PIC16C62A Rev. A Silicon Errata Sheet

The PIC16C62A (Rev. A) parts you have received conform functionally to the Device Data Sheet (DS30234D), except for the anomalies described below.

Clarifications/Corrections to the Data Sheet:

FIGURE 1: SCK PULSE VARIATION USING TIMER2/2

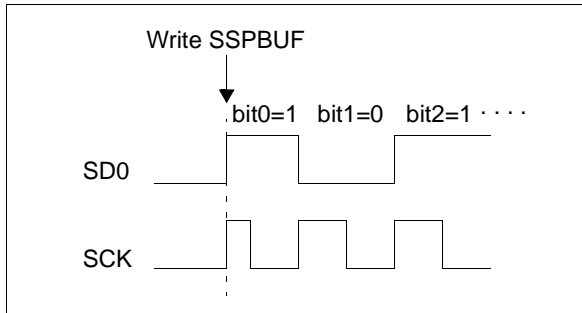
4. Module: SSP (SPI Mode)

When the SPI is using Timer2/2 as the clock source, a shorter than expected SCK pulse may occur on the first bit of the transmitted/received data (Figure 1).

Work around

To avoid producing the short pulse, turn off Timer2 and clear the TMR2 register, load the SSPBUF with the data to transmit, and then turn Timer2 back on. Refer to Example 1 for sample code.

FIGURE 1: WRITES TO TIMER1 (EXTERNAL CLOCK/OSCILLATOR MODE)

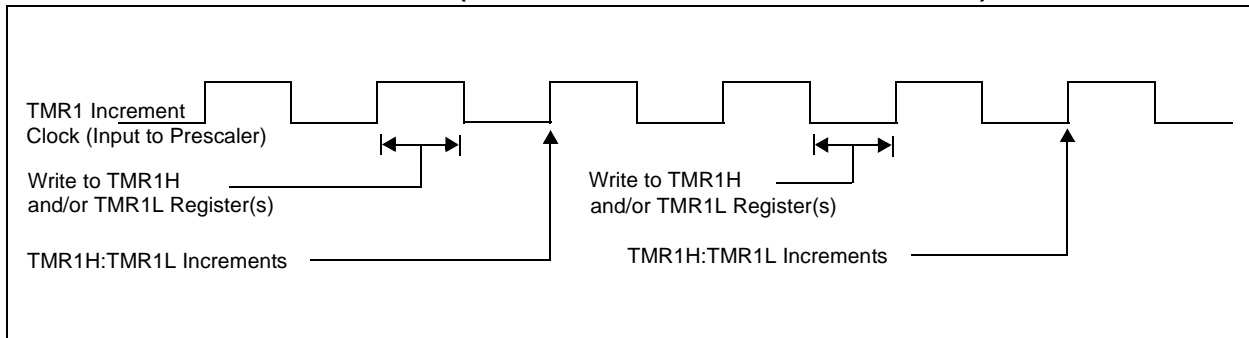
3. Module: Timer1

The operation of Timer1 needs some clarification when the timer registers are written and the TMR1ON bit is set.

The internal clock signal, that is the input to the TMR1 prescaler, affects the incrementing of Timer1 (TMR1H:TMR1L registers and the Timer1 prescaler). When the Timer1 registers are NOT written, the Timer1 will increment on the rising edge of the TMR1 increment clock.

When the TMR1H and/or TMR1L registers are written while this clock is high, TMR1 will increment on the next rising edge of this clock.

When the TMR1H and/or TMR1L registers are written while this clock is low, TMR1 will not increment on the next rising edge of this clock, but must first have a falling clock and the rising clock for TMR1 to increment.

Figure 1 shows the two cases of writes to the TMR1H and/or TMR1L registers. Due to the V_{IH} and V_{IL} thresholds on the oscillator/clock pins, external Timer1 oscillator components, and external clock frequency, the Timer1 increment clock may not be of a 50% duty cycle.

The TMR1 increment clock is out of phase of the T1OSO/T1CKI pin by a small propagation delay.
